Groundwater Application Review Summary Form

Application # G- 19439

PUBLIC INTEREST REVIEW FOR GROUNDWATER APPLICATIONS

A. GENERAL INFORMATION: Applicant's Name: Cornucopia Orchards County: Marion

Well Statistics

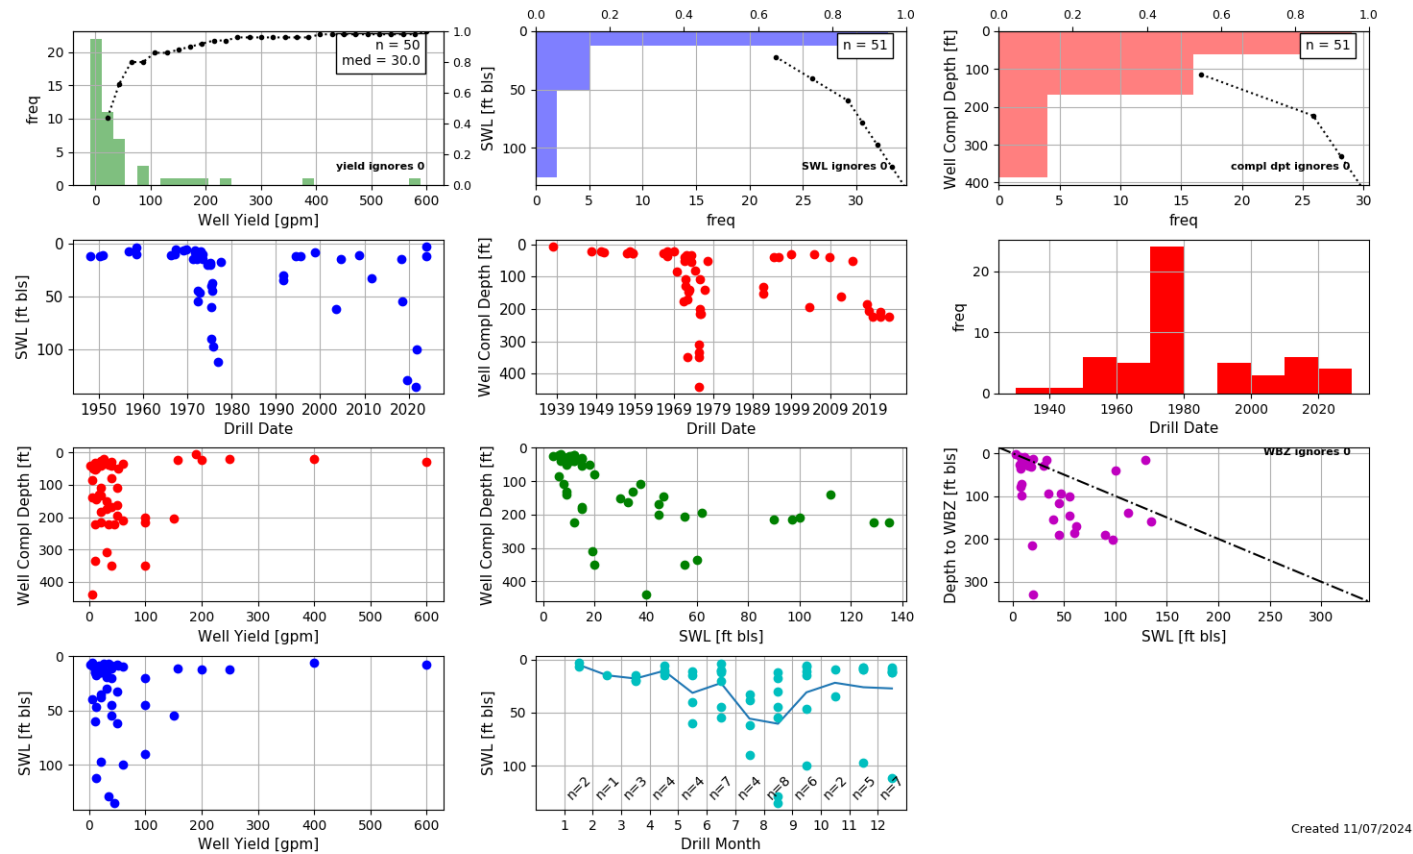
Reported yields from regional wells range from less than 1 to ~ 580 gpm, with a median of 30 gpm (see attached Well Statistics). The requested rate of 0.1336 cfs (~60 gpm) therefore represents ~10 percent of the maximum yield reported for water wells in this area, however it is approximately double the median reported yield. Therefore, it is possible the applicant will be able to achieve the requested pumping rate with the proposed POA, however there is also a possibility that the proposed wells will not yield the desired rate.

Water-Level Measurements in Nearby Wells

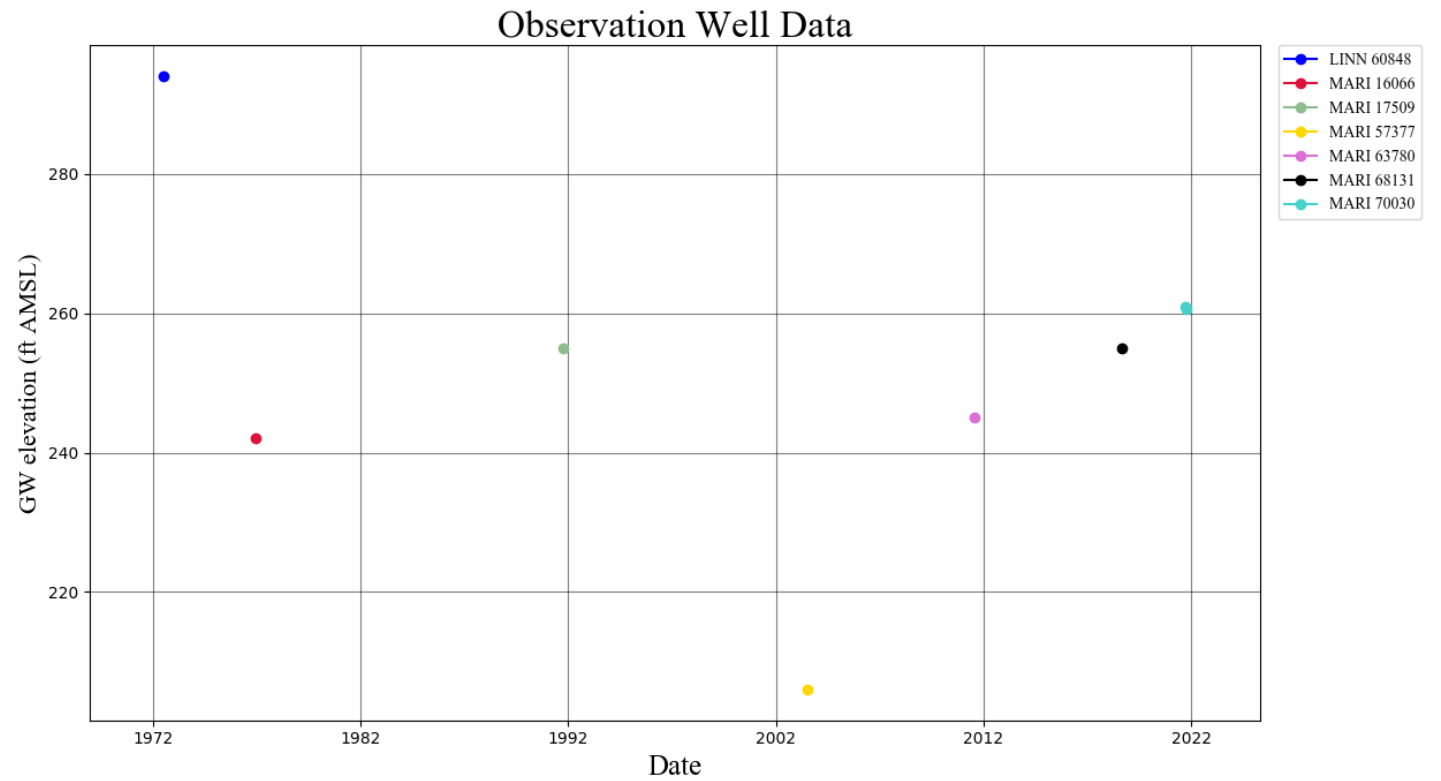
Available water level data are sparse, and display seasonal fluctuation within the aquifer system, but do not indicate or suggest long-term groundwater elevation declines in the area of the proposed use (see attached hydrographs). The closest observation well with a long period of record is LINN 1877, multiple sections away (approximately 4.9 miles).

Theis Interference Analysis

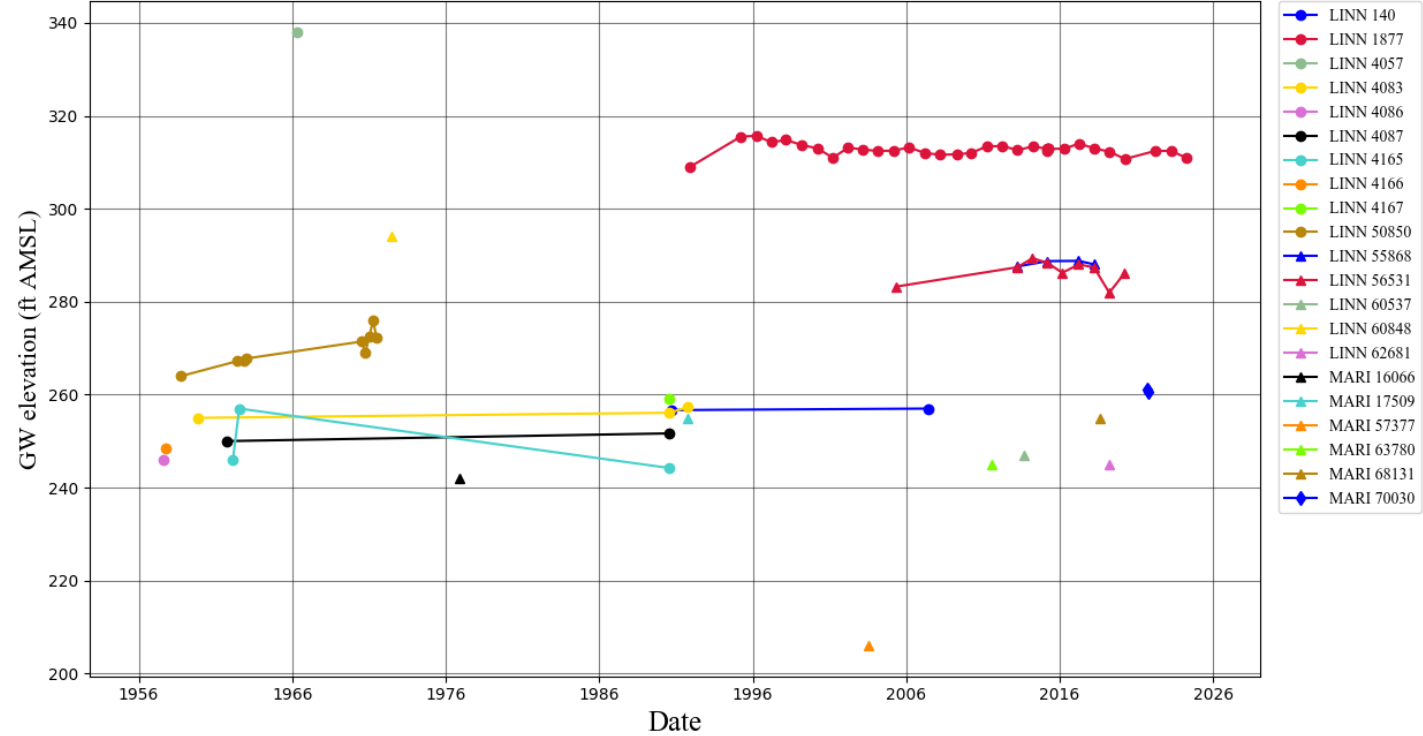
The closest proximity senior water right (Claim GR-1174*IR) is located 670' west of the proposed POA. At this distance, a Theis drawdown calculation utilizing typical values for sands and gravels and a bulk aquifer thickness of 100' anticipate less than 25' of drawdown after one year of pumping at the proposed rate. At the maximum rate (0.1336 cfs), the duty (11.25 af/yr) will be exhausted within 43 days of continuous pumping.
